KS-14580 TELEPHONE ANSWERING
DEVICE (PEATROPHONE)
STATION CONNECTIONS

1.01 This addendum which supplements section C55.604, Issue 1 and replaces addendum Issue A, is issued to provide additional information on connections for the KS-14580, Peatrophone. This addendum should be retained with subsequent issues of the section until notice is given covering its cancellation or reissue.

FIG. A

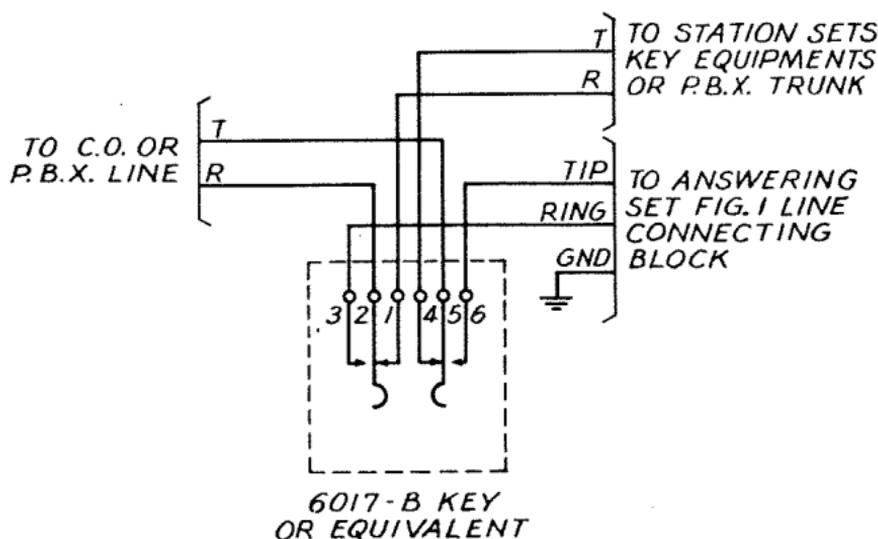
1.04 When the Peatphone set is connected to a line associated with a P.B.X. trunk line, key equipment systems or lines where more than one station is involved, the Answering Set shall be wired as shown in Figure A, below:

CONNECTIONS FOR KS-14580 TELEPHONE ANSWERING DEVICE WHEN USED WITH P.B.X. TRUNKS, KEY EQUIPMENTS, OR WHEN MORE THAN ONE STATION HAS ACCESS TO A LINE.

NOTE: WHEN FIG. A IS USED THE ANSWERING SET MUST BE EQUIPPED WITH A SEPARATE TELEPHONE SET.
